INSPECTION REPORT
OF THE
**LA VERGNE PUBLIC WATER SYSTEM
DRINKING WATER TREATMENT PLANT
LA VERGNE, TENNESSEE**

By
**U.S. ENVIRONMENTAL PROTECTION AGENCY
REGION 4
ENFORCEMENT AND COMPLIANCE ASSURANCE DIVISION
WATER ENFORCEMENT BRANCH
DRINKING WATER ENFORCEMENT SECTION**

November 8 – November 10, 2021

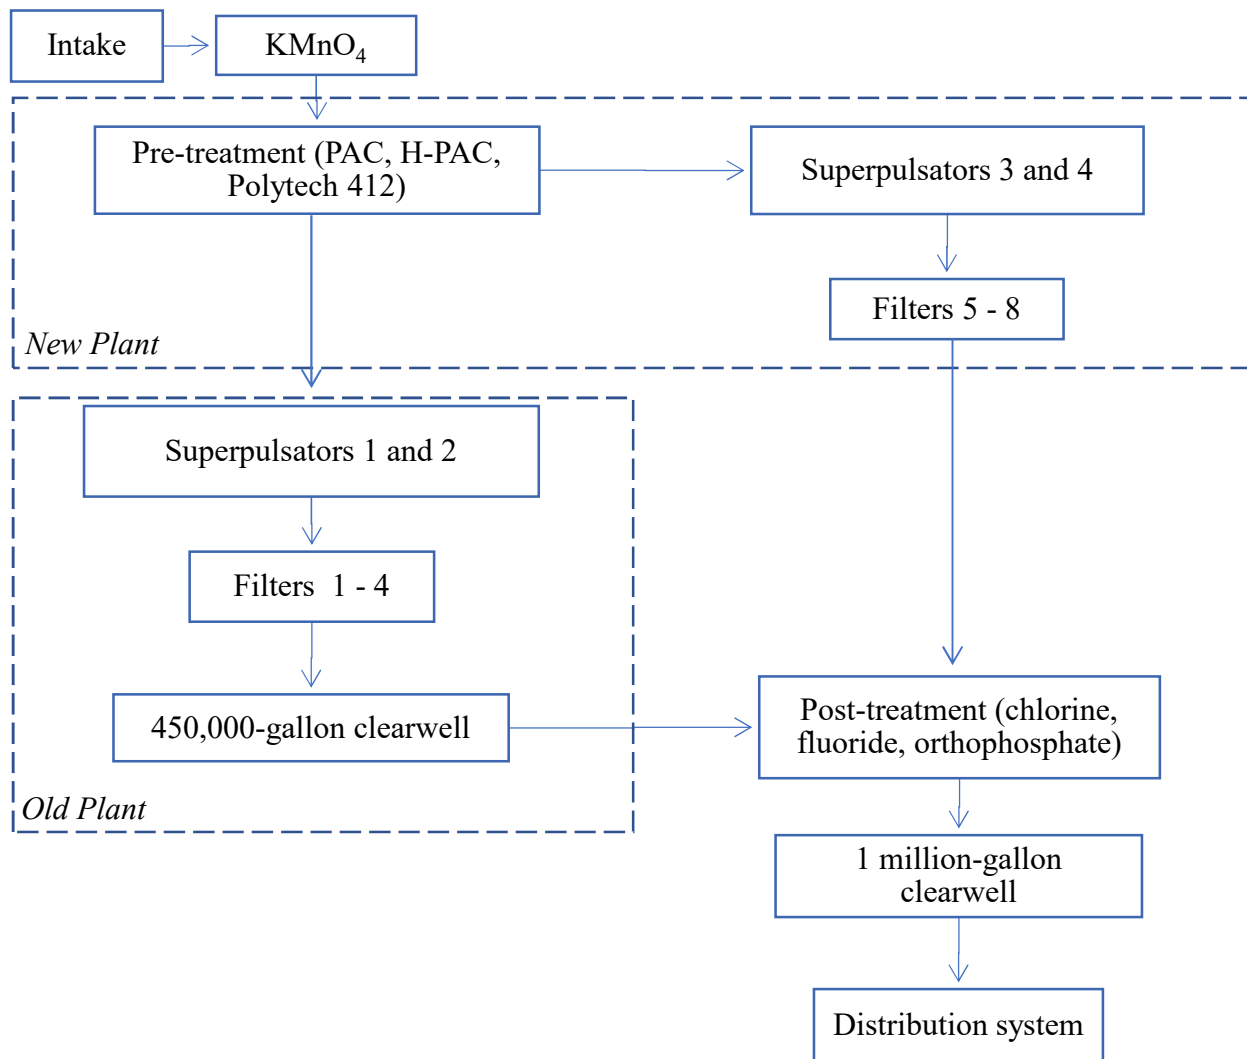
1. **Observation:** TDEC identified an open line on top of the 450,000-gallon clearwell hatch, and it was unclear if the line provided an entry point to the clearwell.

Comments: The system capped the open line while inspectors were onsite. TDEC will follow-up with system to confirm the status of the line.
